TOWN OF PLAINFIELD PLAN COMMISSION REPORT

DATE: 12-01-2025

CASE NO.: RZ-25-069 and PP-25-015

REQUESTED ACTIONS: **RZ-25-069:** Requesting a Zone Map Amendment of 217 +/- acres from AG: Agriculture to:
 R-3: Medium Density Residential: 74.11 acres
 R-4: Medium Density Residential: 115.83 acres
 R-5: High Density Residential: 27.08 acres
PP-25-015: Requesting a primary plat to create 416 lots on 217 +/- acres that have been requested for rezone from AG: Agriculture to R3, R4, and R5.

“Craig Parcel Outlot”

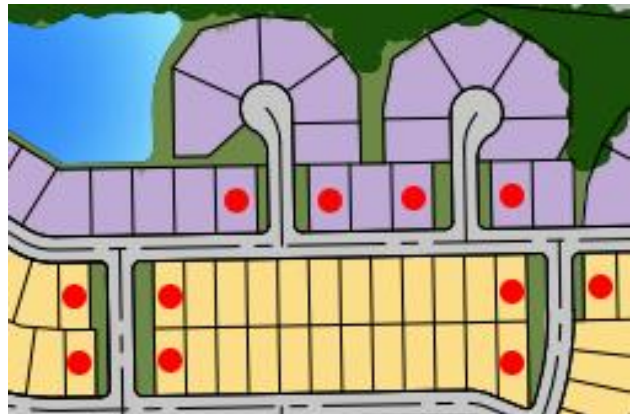
- The lot depicted as “Craig Parcel Outlot” on Exhibit A within the R-5 Written Commitments and the existing house & other structures shall be considered legal nonconforming and the terms of these written commitments shall not apply. If this lot is subdivided, it shall be subject to the terms of these written commitments.

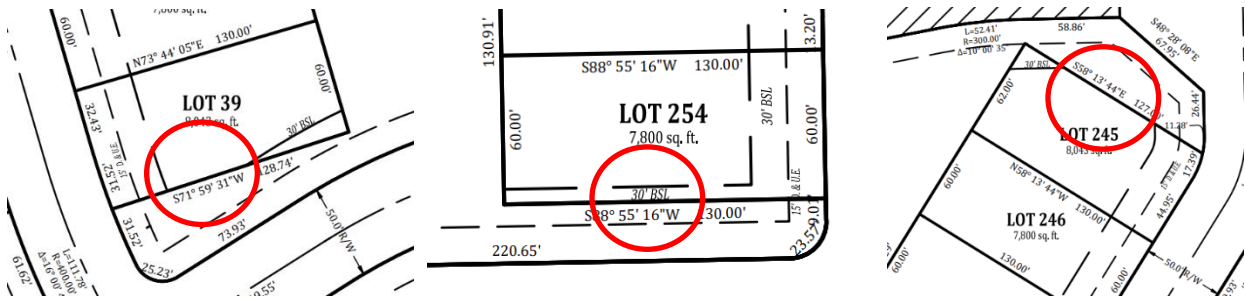
There are multiple concerns regarding building setback lines as it relates to the submitted Primary Plat. In some instances, no building setback line is shown, in others it is incorrectly measured. Examples of both are shown below.

In all three examples above, the required 30' building setback line has either been incorrectly placed or omitted entirely. These concerns were raised in detail in an email to the applicant's engineering firm on 10-21-2025. A revised Primary Plat was received on 10-23-2025. The concerns raised in this report remained on the resubmitted Primary Plat.
